ADDENDUM TO INVITATION TO BID

PROJECT: **BID #D00424 – STAUNTON CROSSING – ELEVATED WATER STORAGE TANK**

DATE: **MAY 9, 2024**

ADDENDUM: **1**

JOB NO.
49408
SHEET NO.
T1.0

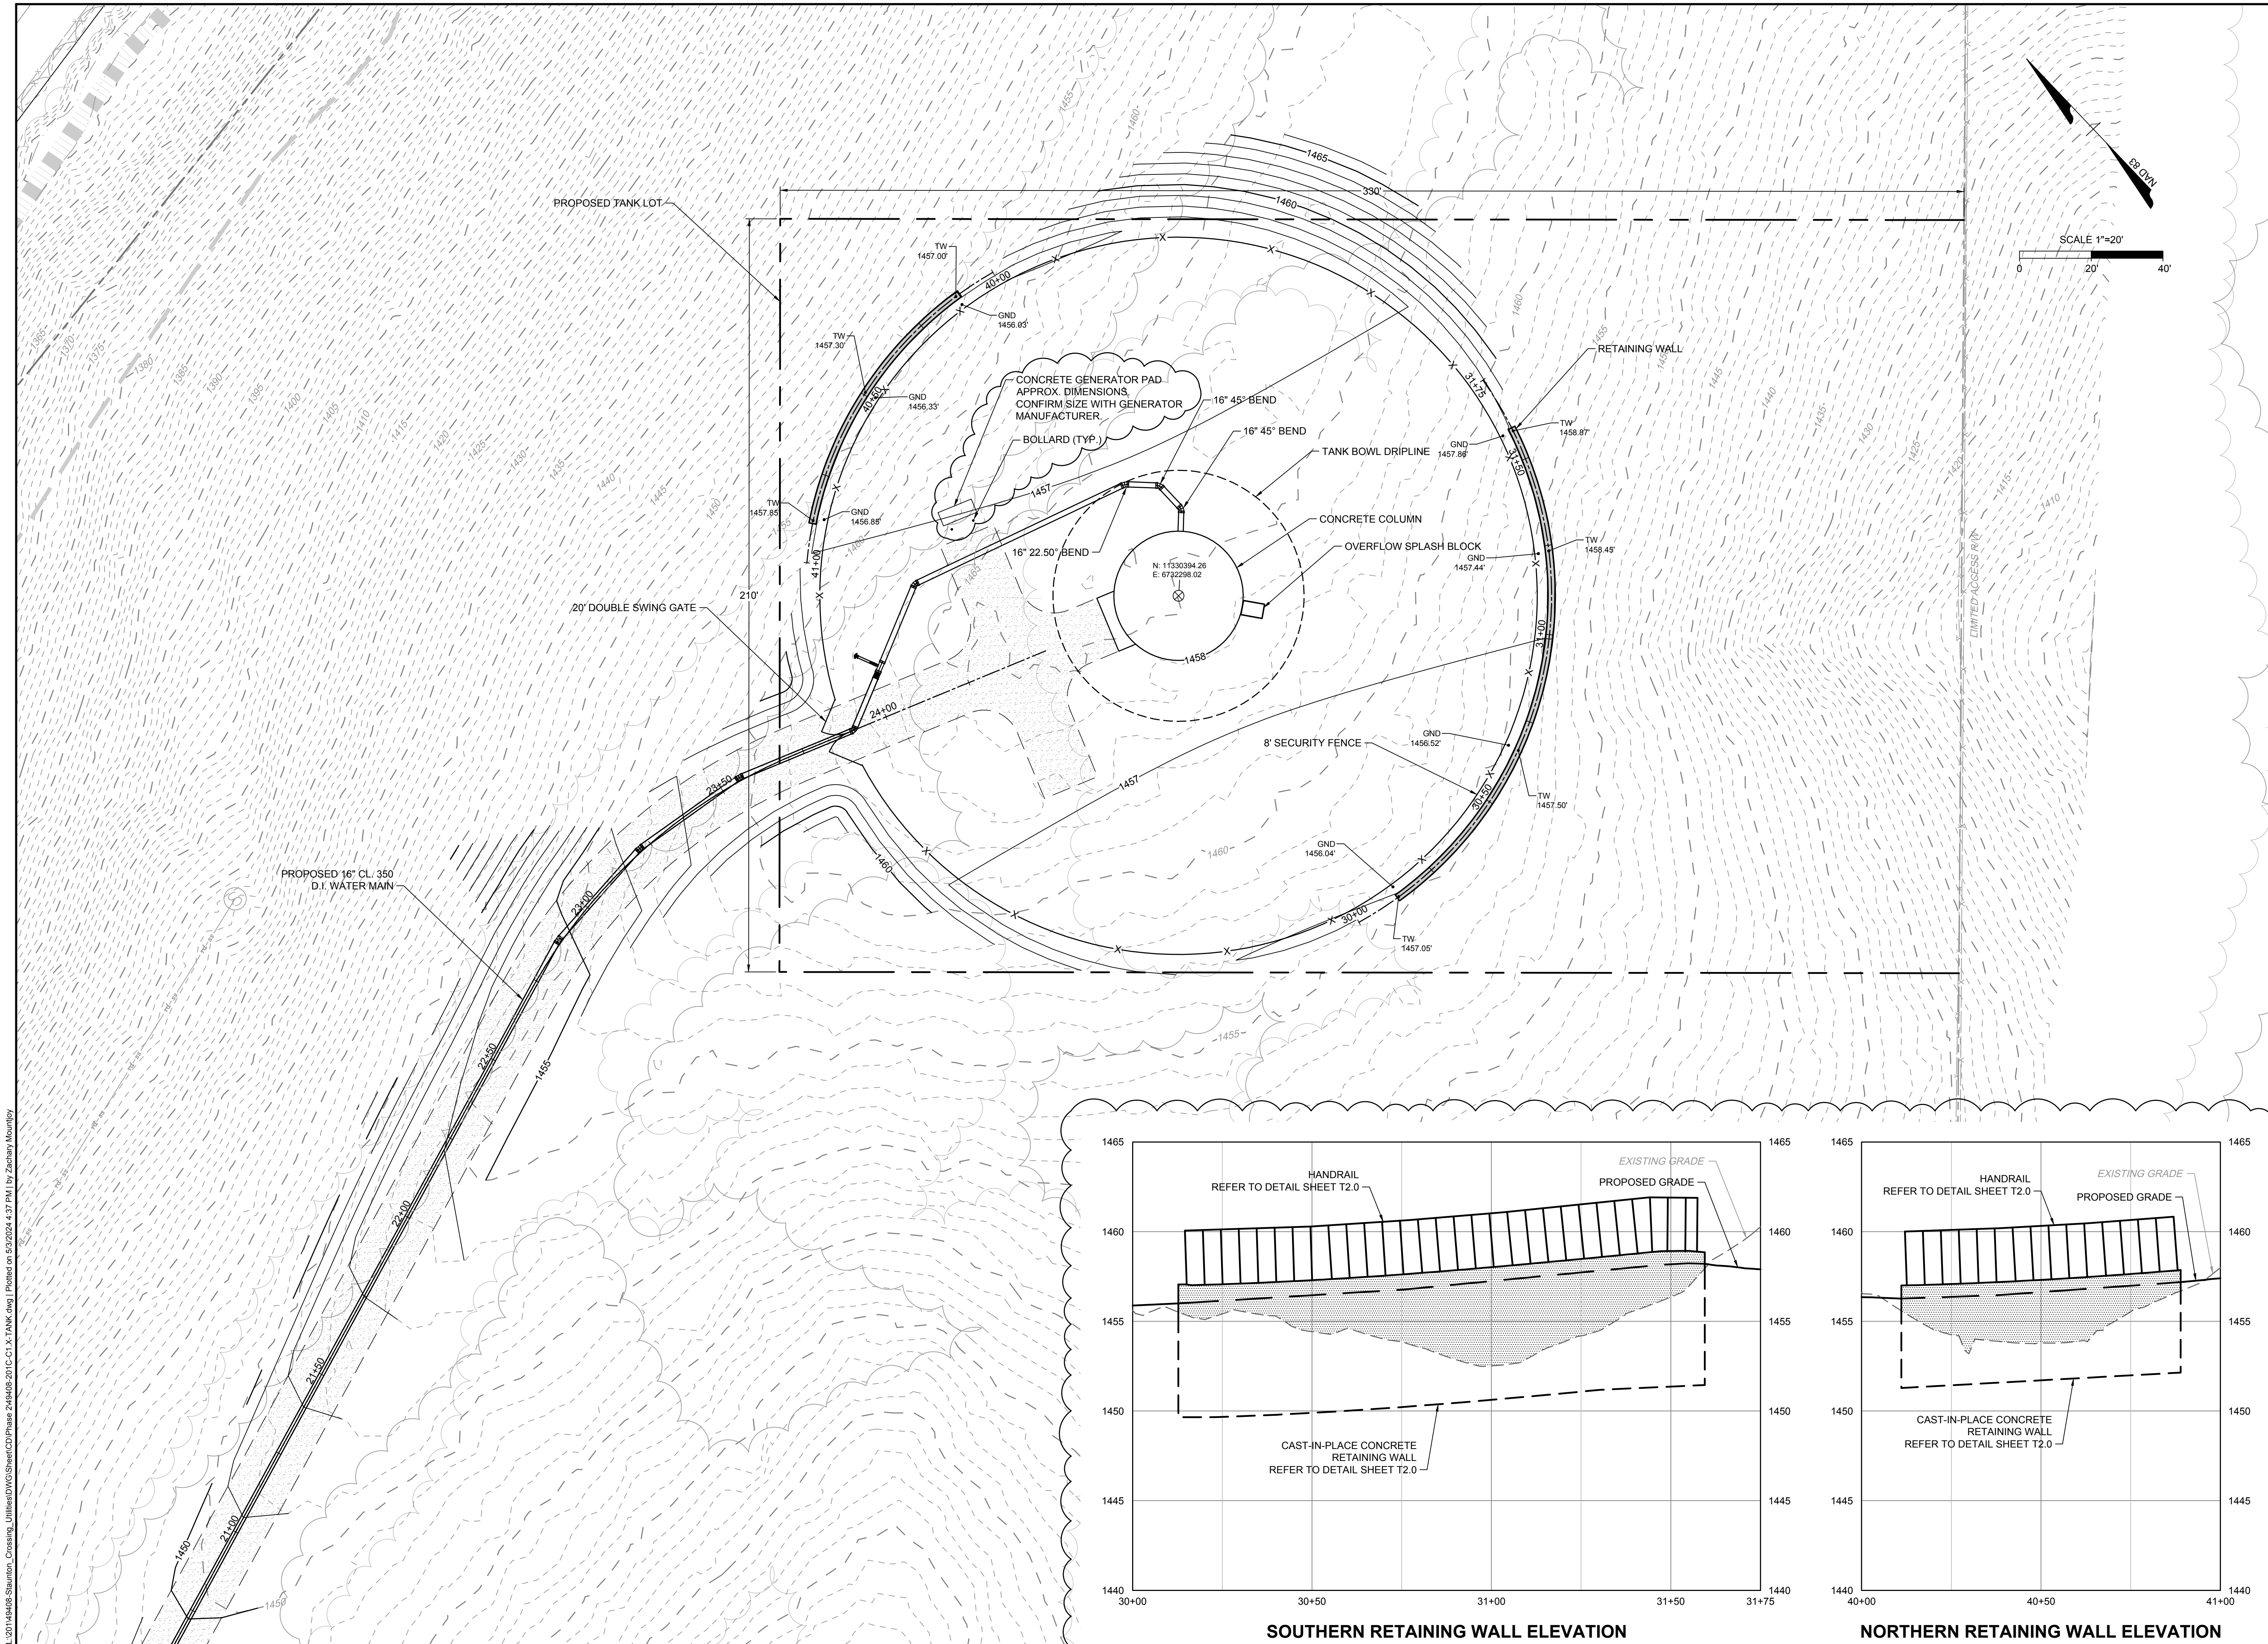
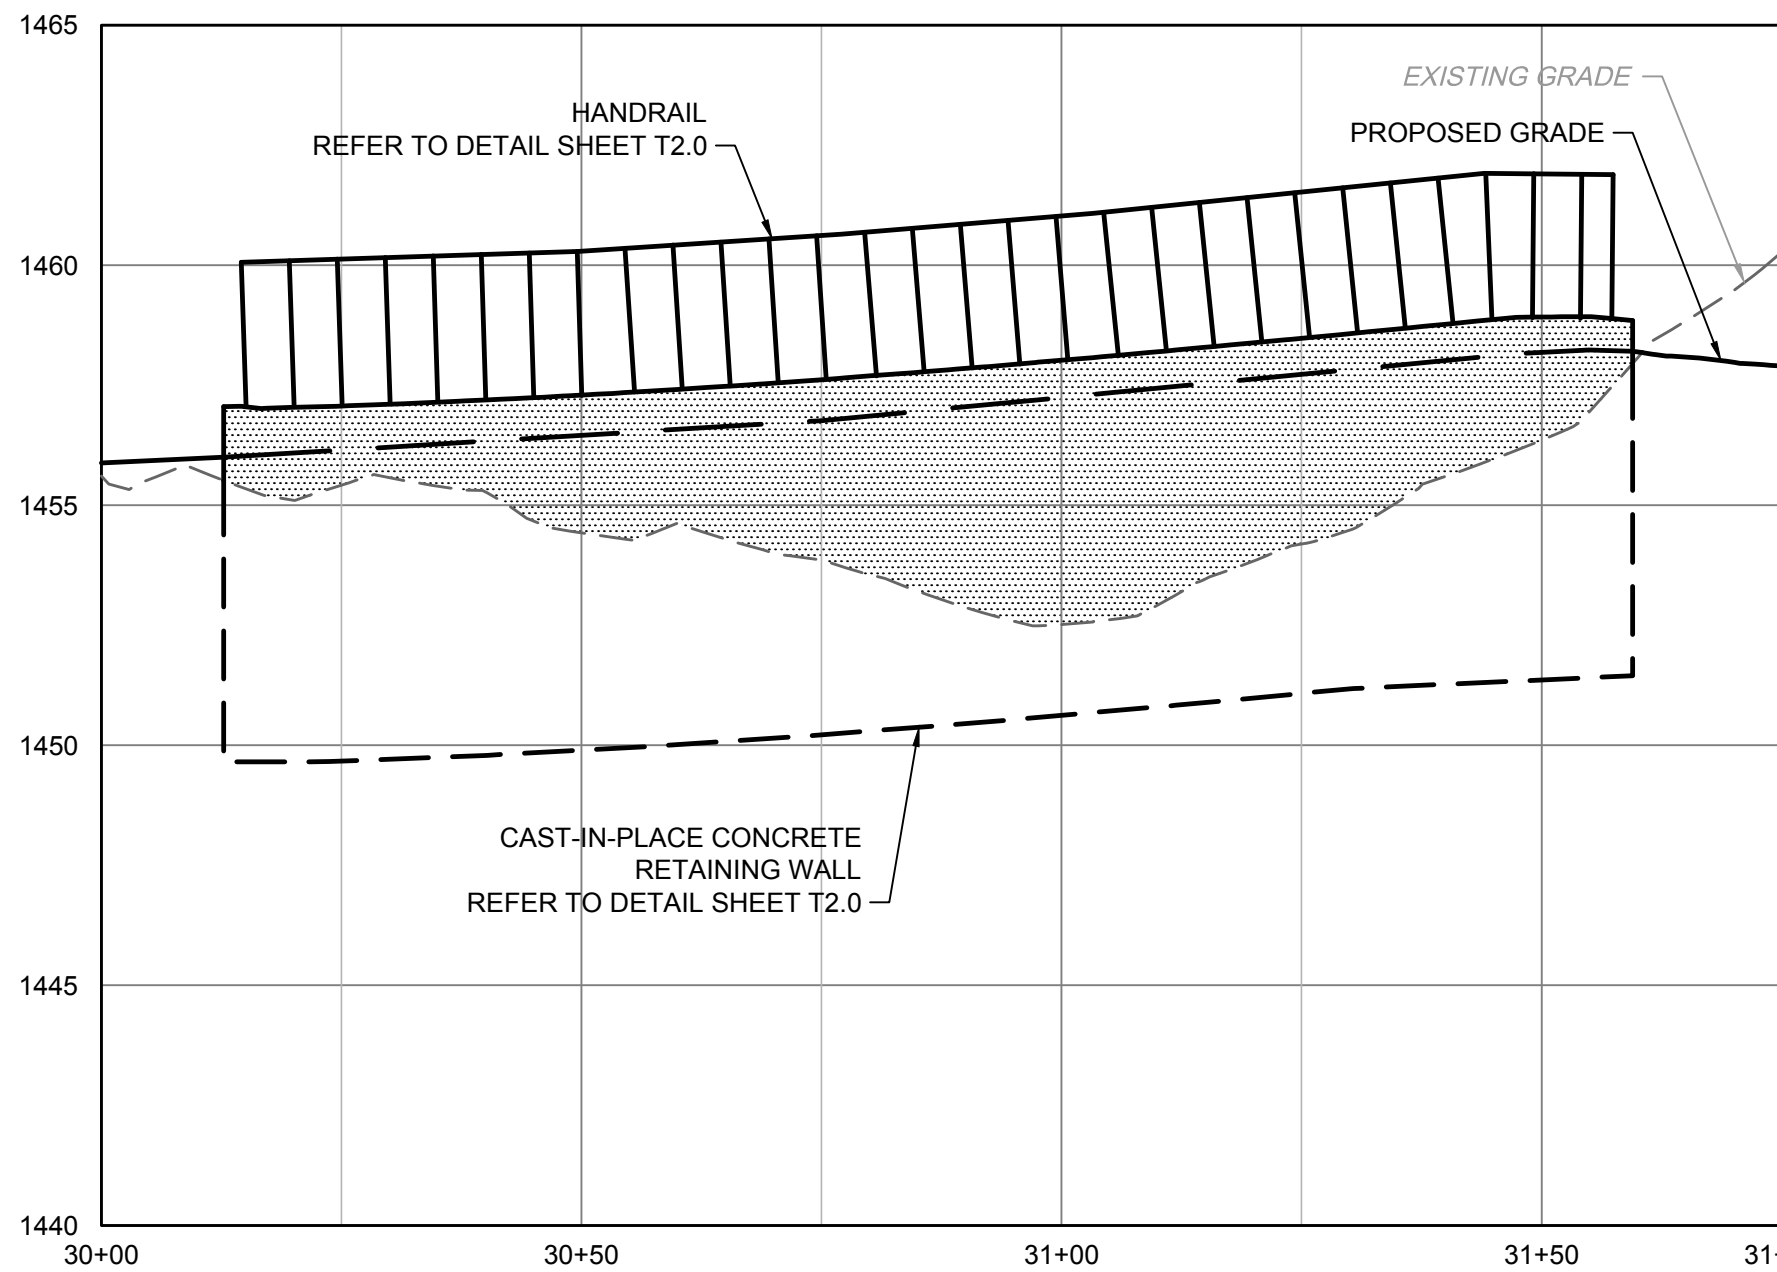
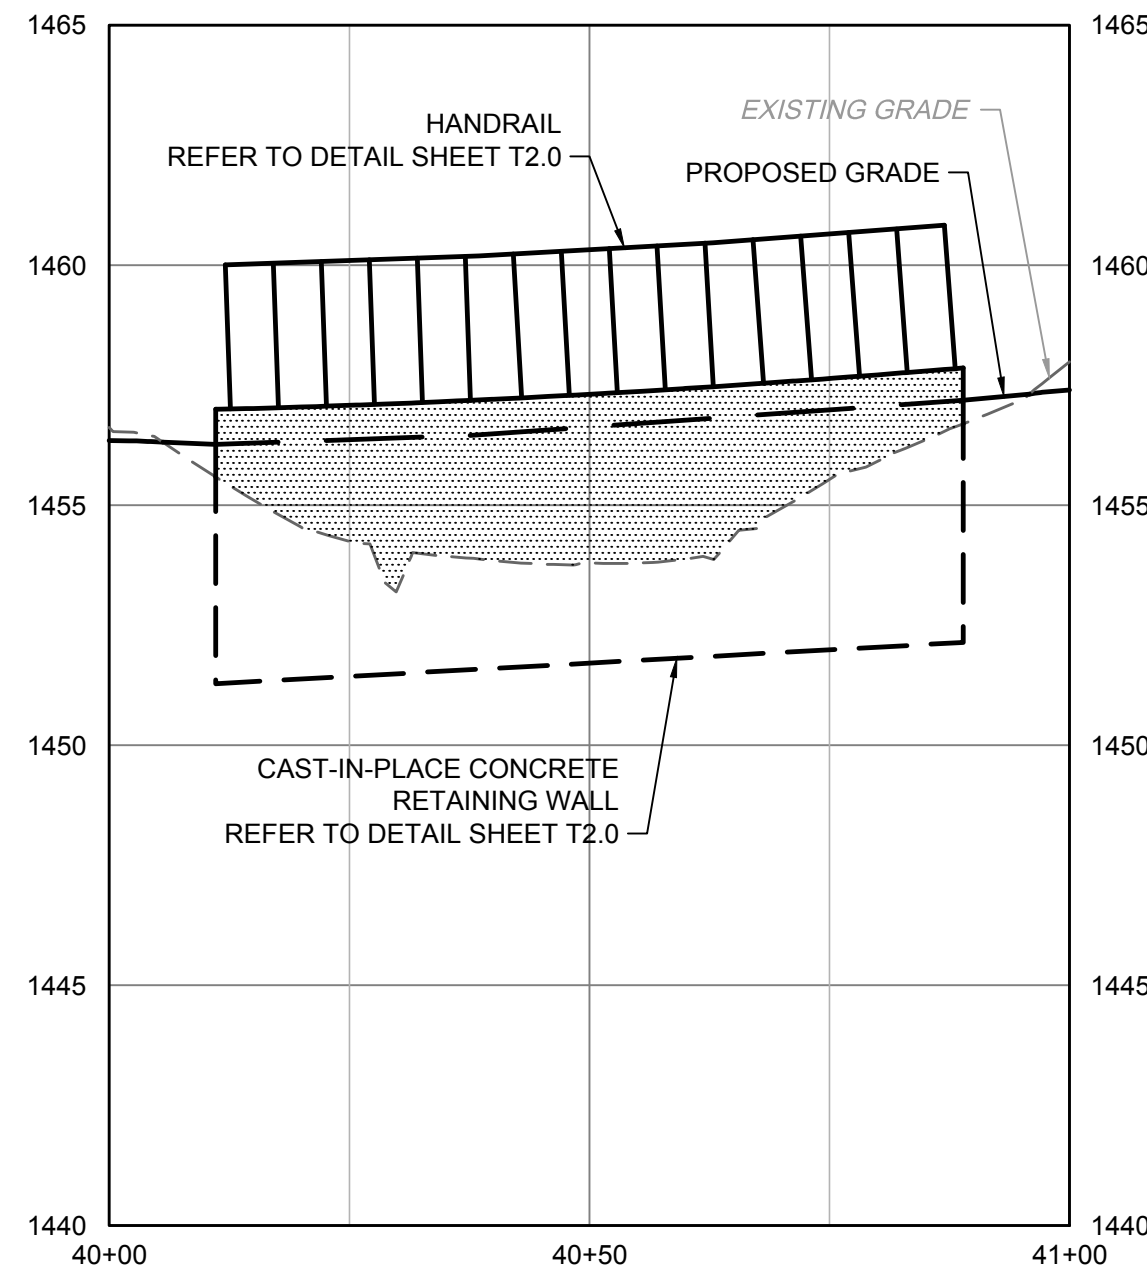
1. Drawings W1.0 and W1.1 have been revised to call out the “Staunton Crossing – Onsite Water and Sewer Extensions” project for the water main connection.
2. Drawings T1.0 and T2.0 have been revised to detail the retaining wall, show bollards in front of the generator pad, and instruct Bidders to confirm generator pad dimensions with generator manufacturer.
3. Drawing M2.1 has been revised to show the Overflow Splash Block detail.
4. Specification 01 4000 Part 1.2, A: revised to clarify responsibility of testing and inspections.
5. Specification 13 2100 Part 2.1, A: Water Storage Tank design standard revised to reference AWWA D107 for Composite Elevated Water Storage Tanks.
6. Specification 13 2100 Part 2.4, F.5: Interior Field Finish Coat revised to specify Tnemec Epoxoline Series 21.
7. Specification 13 2100 Part 2.4, I: revised to allow interior coating after the bowl is raised.

42. Sheet T1.0 – A retaining wall is shown to be installed on the north and south ends of the tank site. Can a detail of the retaining wall be provided indicating the wall material type, wall design, and foundation design?

43. Sheet T1.0 – A generator pad is shown to be installed. Can a design details, including size, thickness and reinforcing requirements, be provided for the generator pad?

Response: Please refer to revised sheets T1.0 and T2.0 for details regarding the retaining wall.
